SUBJECT: Docket 71-9297, Amendment Application - Certificate of Compliance No. USA/9297/AF-96 for Model No. TRAVELLER

Application for Certificate of Compliance for the Traveller PWR Fuel Shipping Package

8	May 2010	Add CE16NGF and CE16VA fuel assemblies to criticality safety evaluation. (Ref: LCPT-10-14)

Figure 6-5 Water Reflected fuel assembly contents in range of package confinement

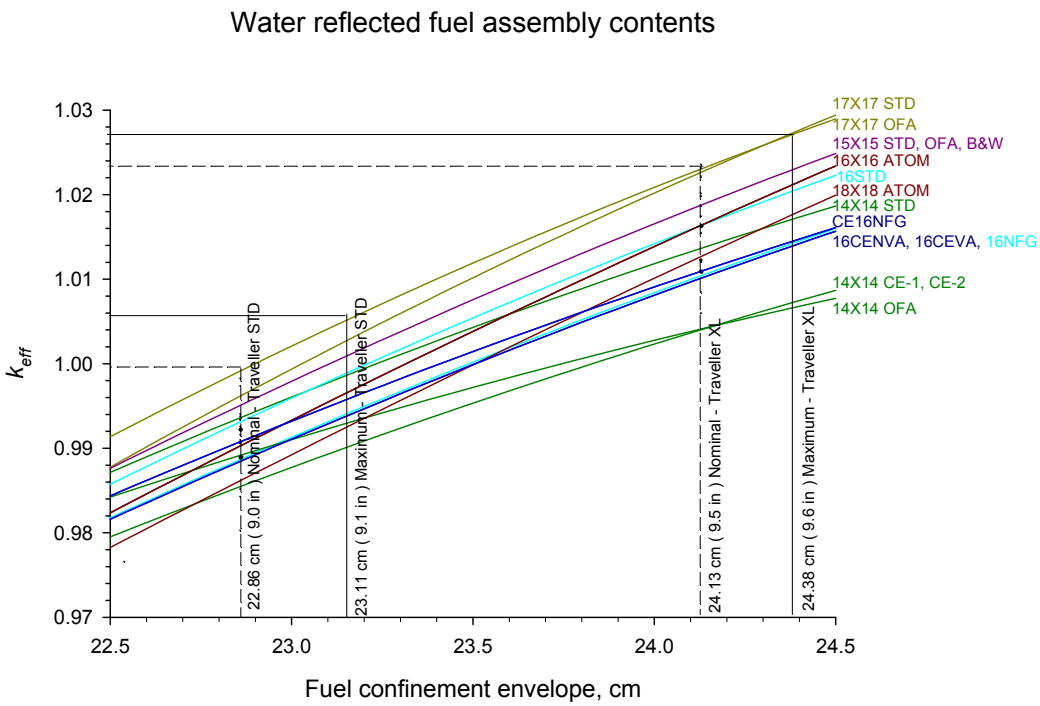
Record of Revisions	Rev. No. 8
List of effective pages	Rev. No. 8 pages
Figure 6-5	Replaced with new figure showing results for CE16NVA, CE16VA, and CE16NFG.
Table 6-22	Revised to include parameters for CE16VA, and CE16NFG.
Section 6.10.2	Discussion revised to explain the selection of the 17X17 OFA as the reference contents for the package evaluation.
Table 6-24	The original application only included the 18X18 ATOM, 17X17 OFA and 17X17 STD fuel assembly types. Table 6-24 has been revised to include all fuel assembly types approved in the CoC, and the additional two 16X16 CE fuel assembly types. There are six 16X16 fuel assembly types (16STD, 16NFG, 16ATOM, CE16NVA, CE16VA, and CE16NFG) associated with 3 different lattice designs as follows (Westinghouse, ATOM, and CE) shown in Figure 6-21 of the application. Table 6-24A was added to show a summary of the keff results in Table 6-24 with a ranking assigned to the keff values for each fuel envelope confinement dimension.

This analysis indicates that the 17x17OFA is the most reactive fuel assembly over the range of interest. However, the difference between the 17x17STD and the 17x17OFA is less significant at the top end of the range (9.6 inches/24.384 cm). The 17x17OFA is the most reactive contents and fuel assembly to use in all calculations.

Figure 6-23 Comparison of Fuel Assemblies – Individual fuel assembly, 20 cm water reflection, 100 cm lattice expansion

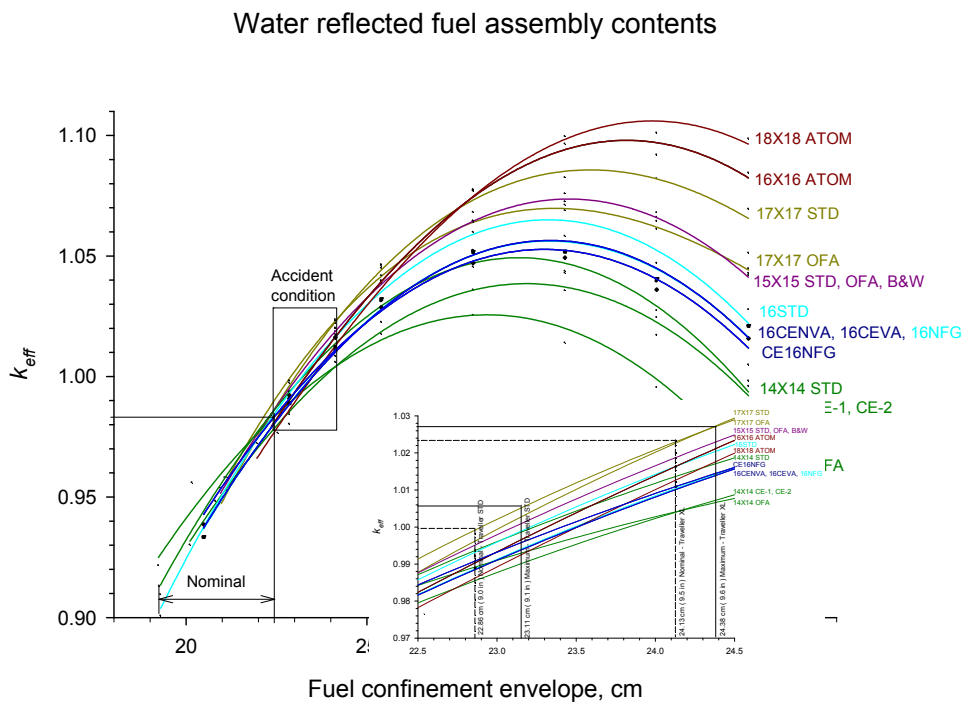
Figure 6-23	Replaced with new figure showing results for CE16NVA, CE16VA, and CE16NFG.
